**KINGSWAY, 67 (LOT 500) MADELEY,
KING DAVID BOULEVARD, 39 (LOT 501) MADELEY –
CHILD CARE CENTRE**

Form 1 – Responsible Authority Report
(Regulation 12)

| LG Reference: | DA2022/988 | |
| DAP File No: | DAP/22/02308 | |

| project | LD | description | PROPOSED OVERALL SITE PLAN | |

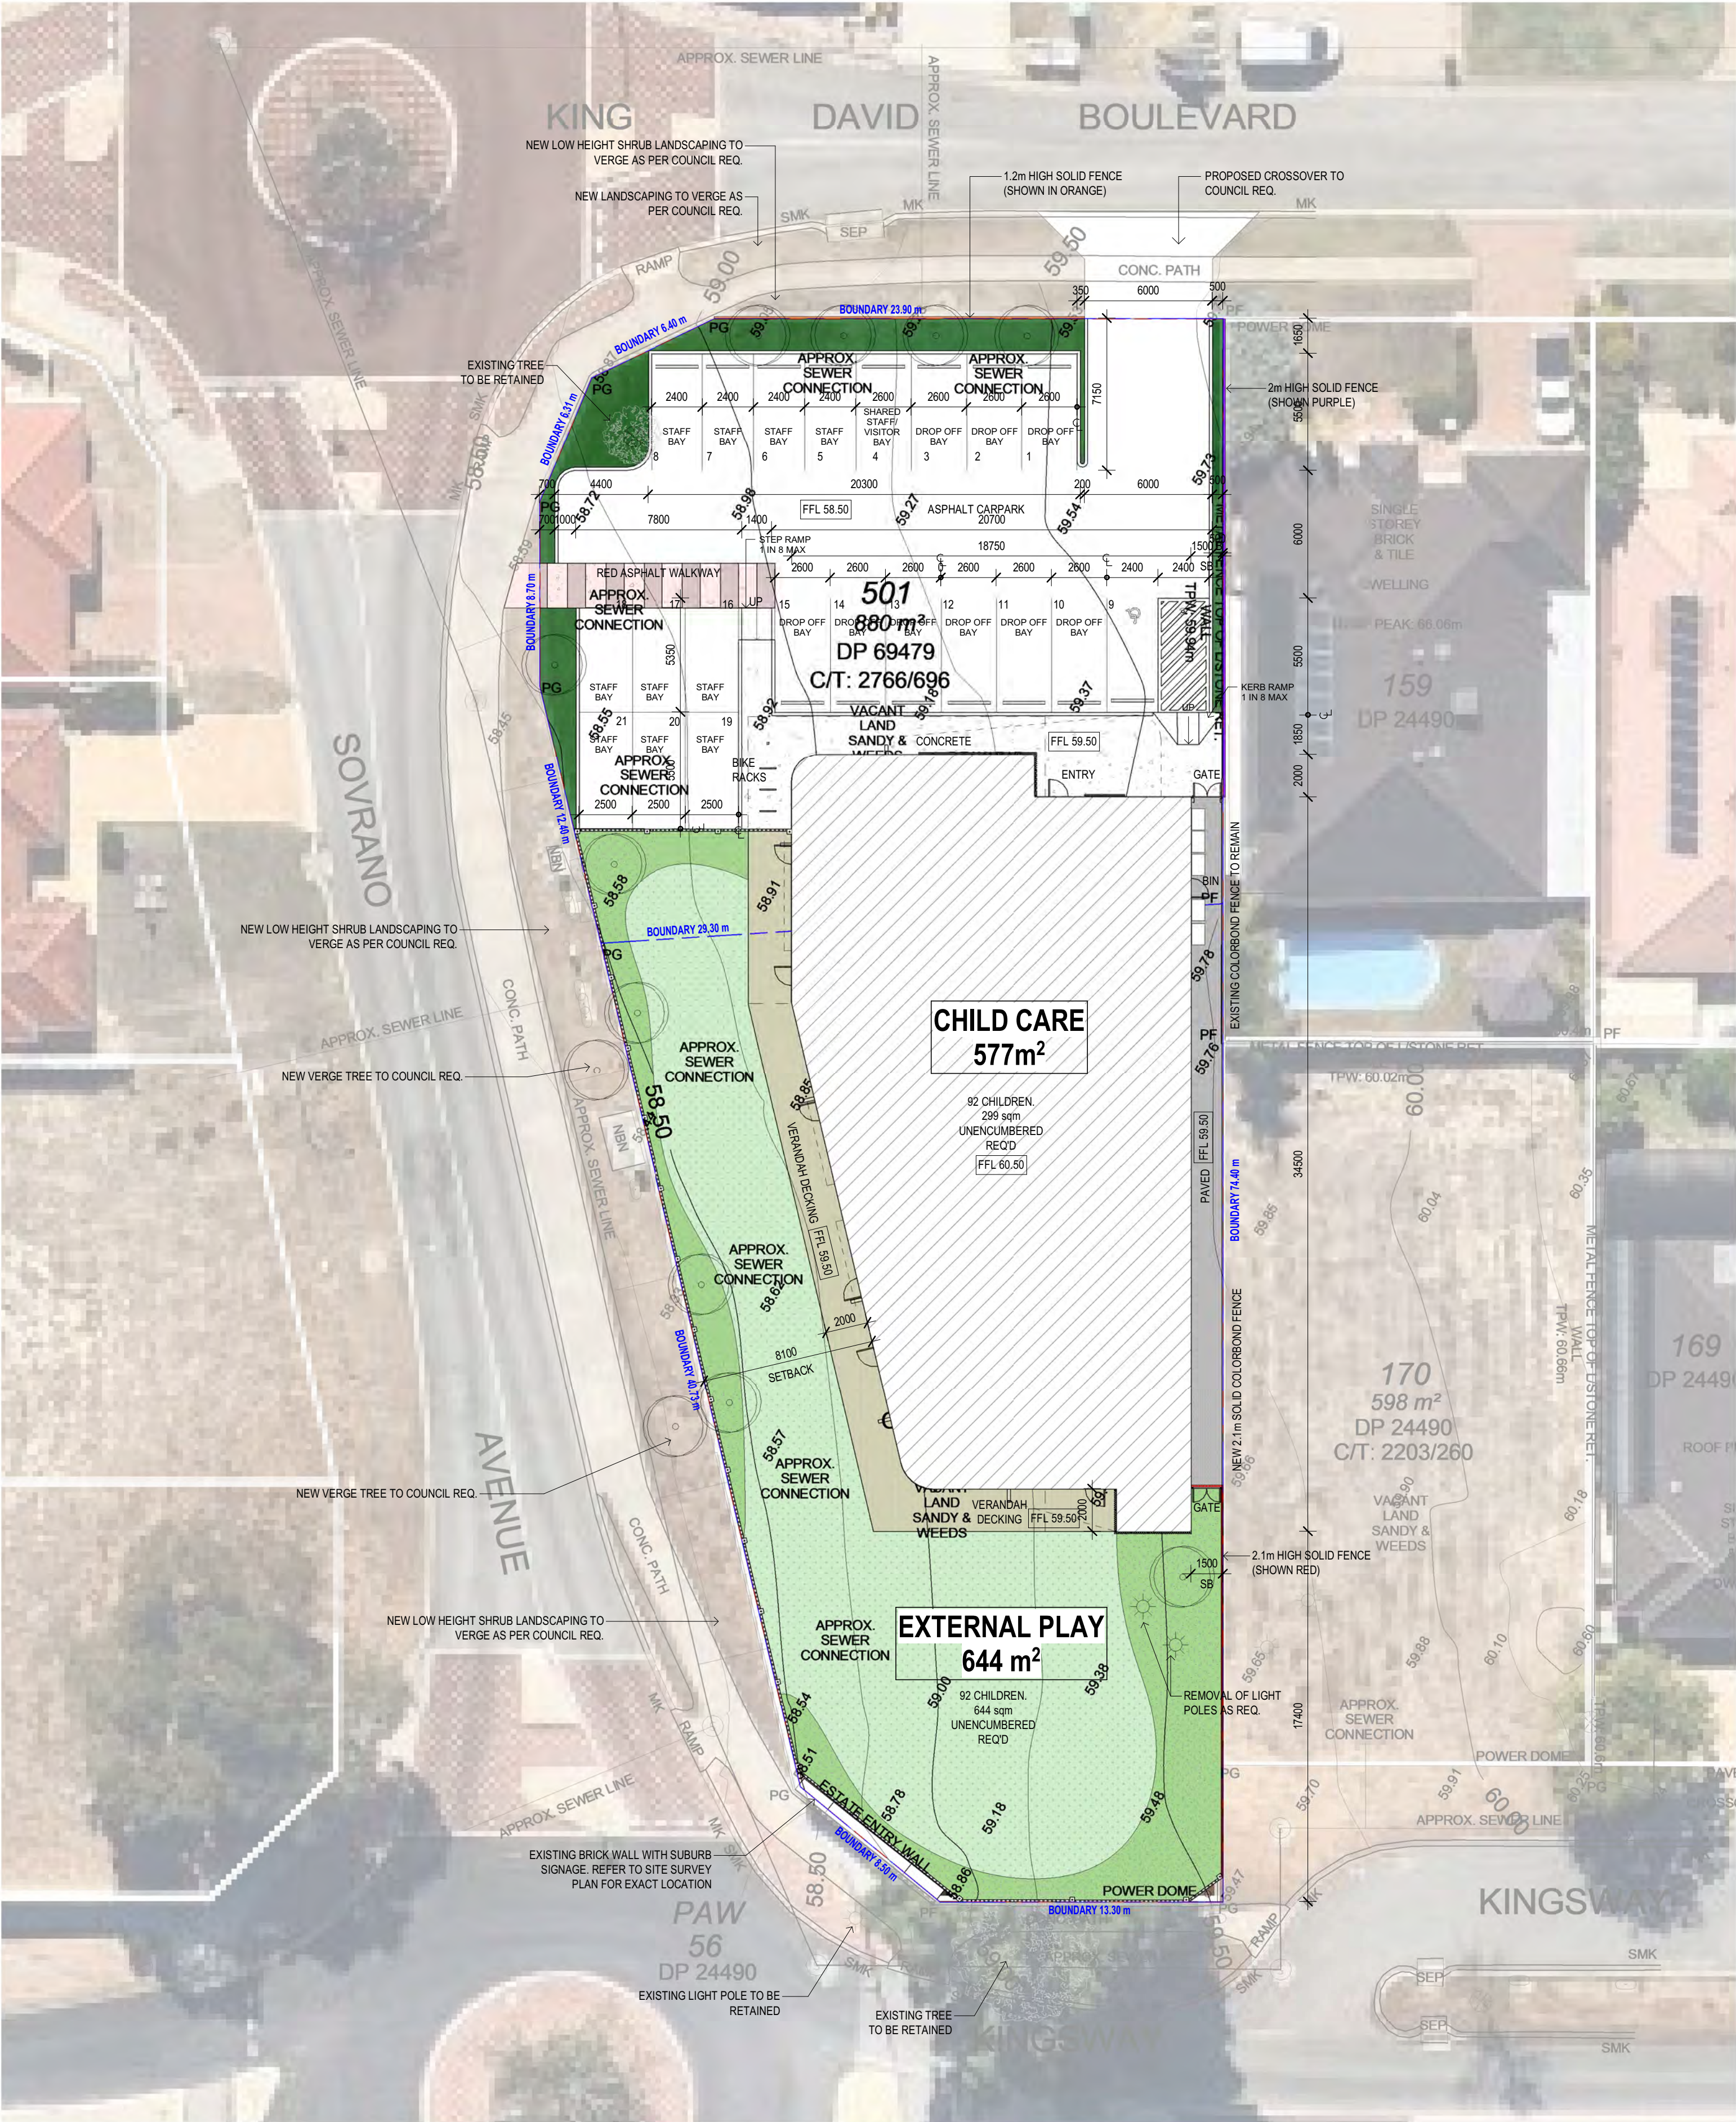
- The floor plan has been designed to have no major openings abutting the eastern boundary, minimising concerns regarding visual privacy;
- The City recommends the bin store area be relocated to the western side of the site so that it does not impact the adjoining neighbour. This is discussed later in the report;

Despite the fact that the proposed bin store is screened by a 1.8 metre high dividing fence, the proposed location for the bin store as shown on the plans in **Attachment 1** is not considered to be suitable due to its close proximity to the adjoining residential property. The location of the bin store does not satisfy Clause 67 (n) of the Deemed Provisions of the *Planning and Development (Local Planning Schemes) Regulations 2015* as the proximity of the bin store to the neighbouring property's outdoor living area is considered to negatively impact their amenity such as odour and noise impacts.

9. A revised site plan and elevations are to be provided demonstrating the relocation of the bin store to the western side of the site away from the adjoining residential property as generally annotated on the approved plans. The bin store shall be screened from the street and car parking areas with a minimum 1.8 metre high solid fence. The screening/fence shall be designed to match the materials and colours of the proposed fence along Sorvano Avenue, to the satisfaction of the City. The revised plans shall be provided to the City for approval prior to an application for a building permit being made.

It is recommended that a condition be imposed requiring the bin store be relocated to the western side of the site, as annotated on the plans in **Attachment 1**. The bin store needs to be screened by a wall not less than 1.8 metres in height. Therefore the fence proposed along Sorvano Avenue will need to be extended to the north to screen the bin store from the street. The screening for a bin store is to comprise a 1.8 metre high solid wall. The materials and colours match the proposed fence along Sorvano Avenue to ensure a consistent streetscape.

| project | PROPOSED MADELEY CHILDCARE CENTRE | drawn LD | description | PROPOSED LANDSCAPE PLAN |

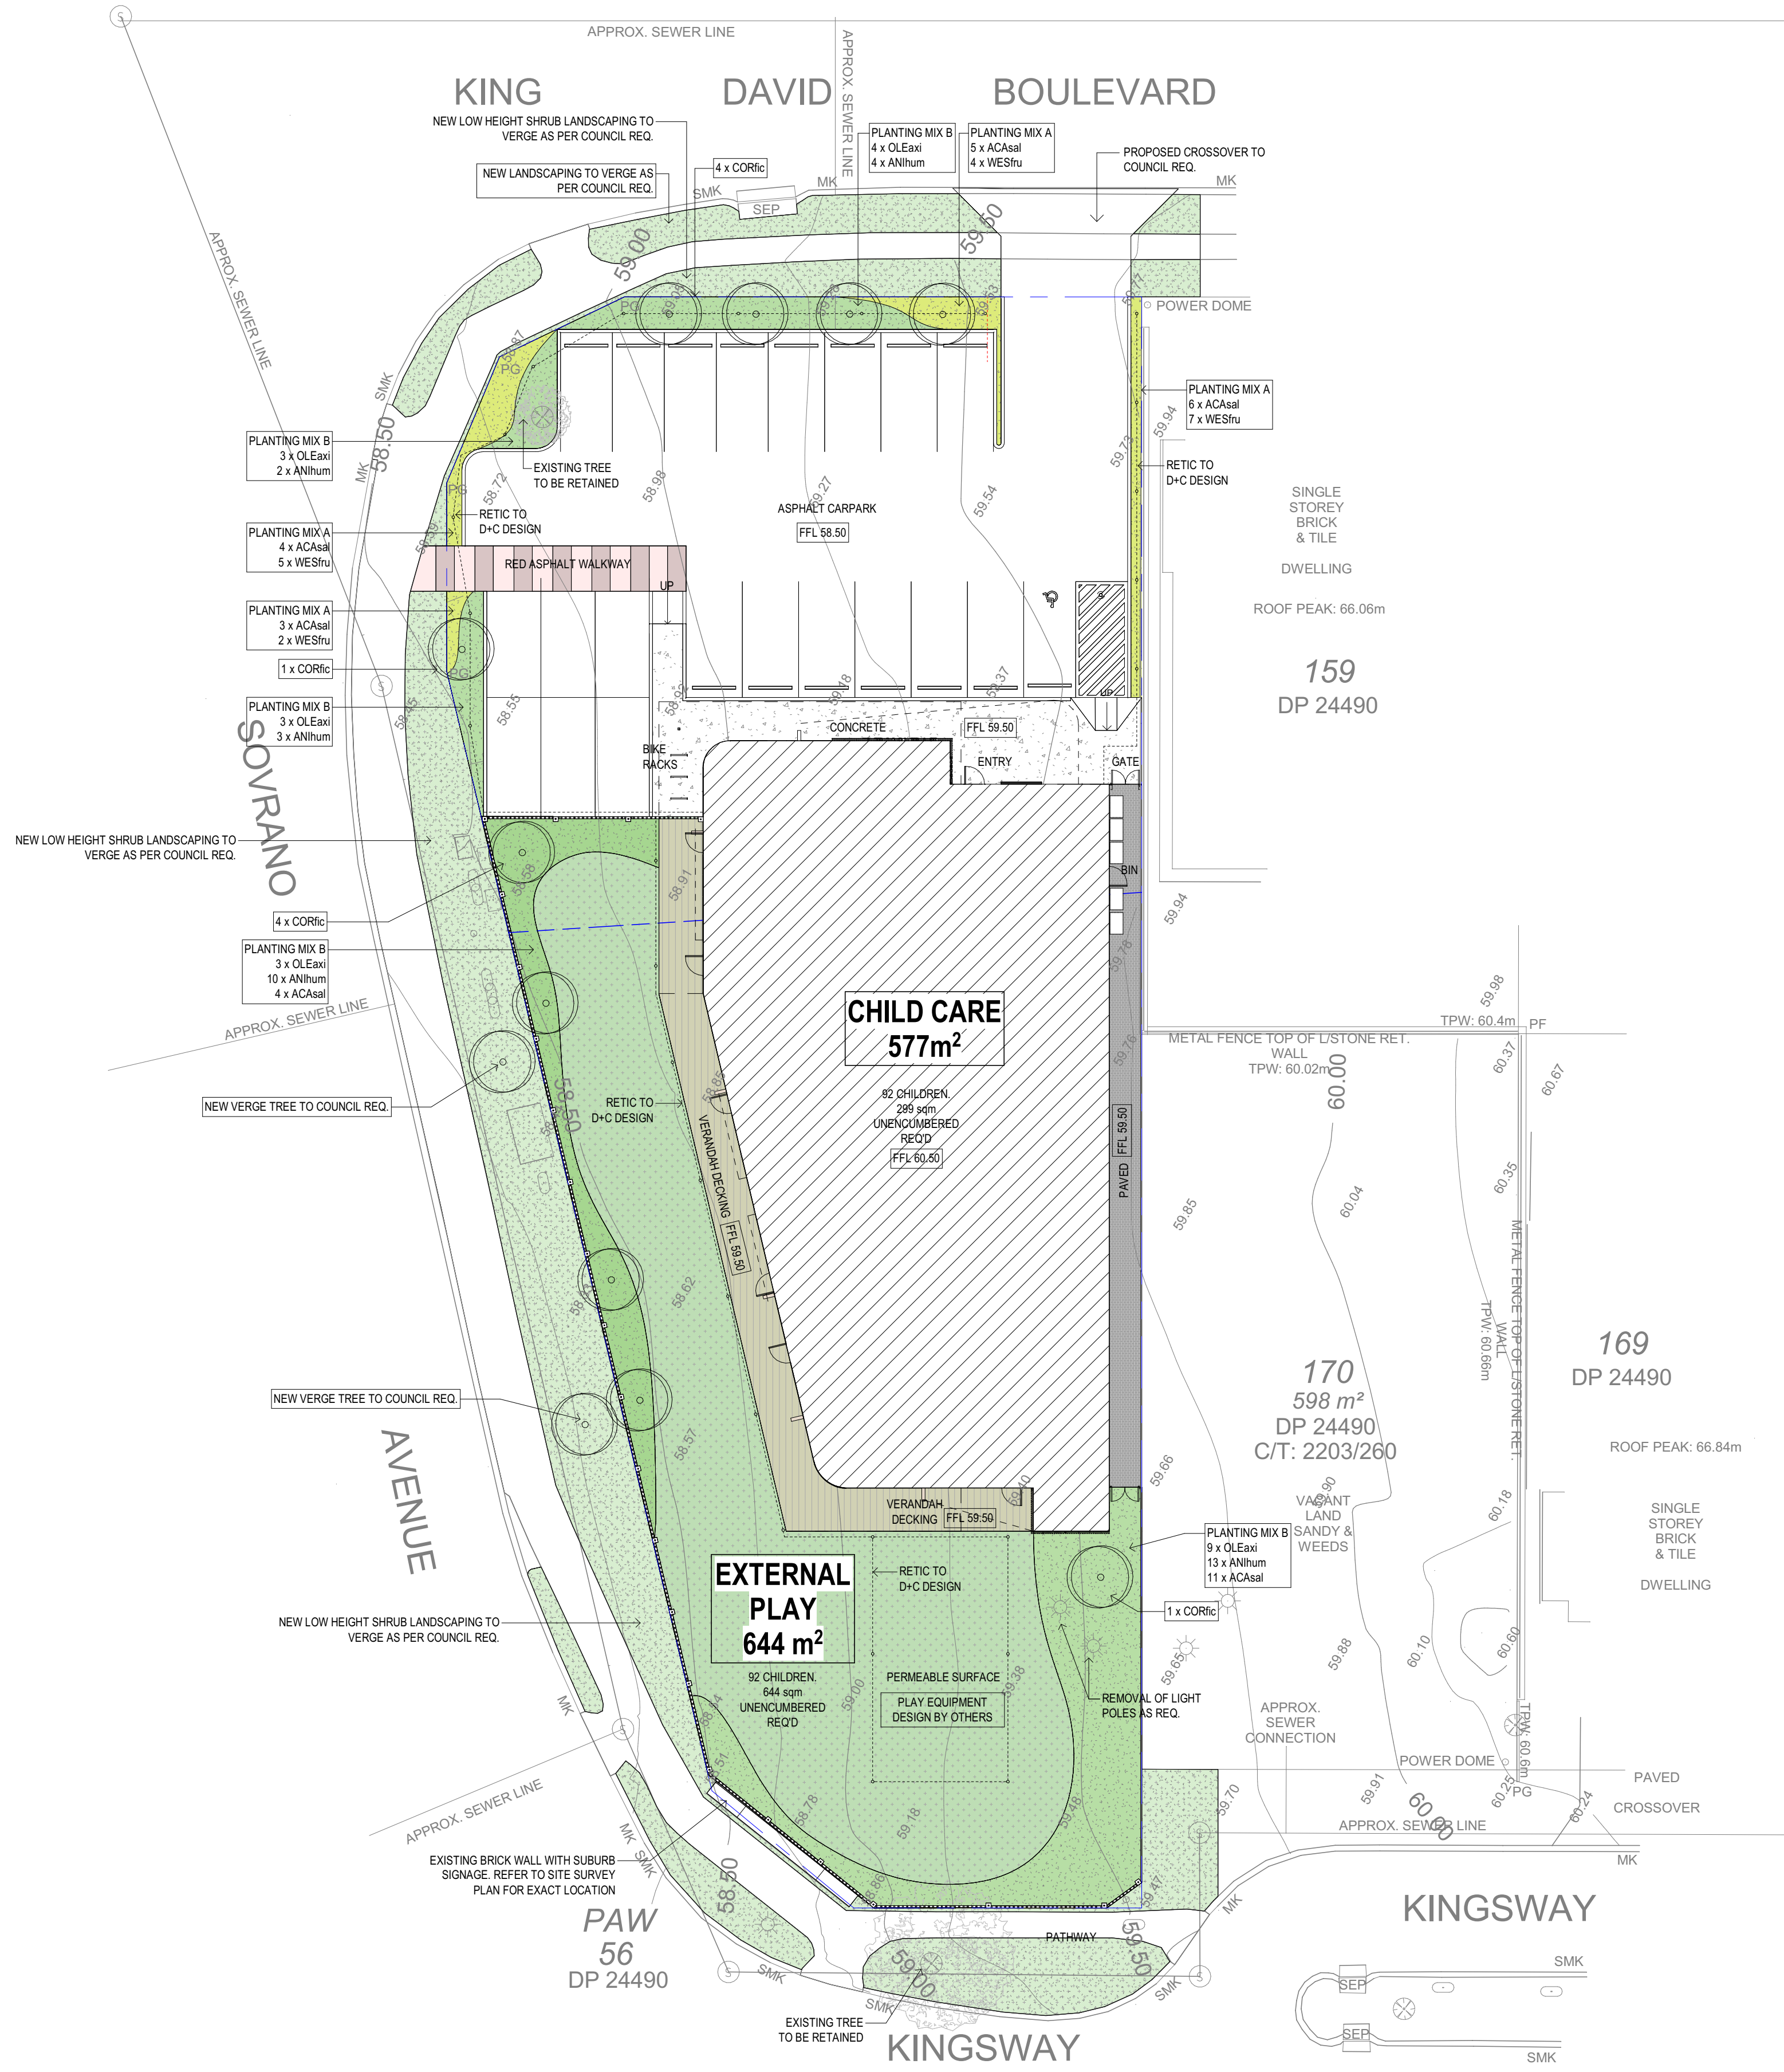
| DPS 2 Provisions | Proposal |
|---|---|
| <u>Clause 4.17.4</u> Designed to improve visual appeal of development from street. Use of endemic trees and shrubs are encouraged. | Additional planting and planting species are required. |

Whilst the landscaping plan in **Attachment 1** incorporates landscaping within the verge, the City requires additional planting to be provided. The City recommends a condition be imposed requiring a revised detailed landscaping plan be provided which includes additional planting within the verge, an additional 5 trees to be planted on-site around the outdoor play area, and detail of the plant species.

8. A revised detailed landscaping plan is to be provided for the subject site and adjacent verges which includes additional landscaping within the verge considering sightlines, and an additional 5 trees to be planted on-site around the outdoor play area. The revised landscaping plan shall detail the plant species, densities, confirmation on mulch details, planting locations, and shade trees,
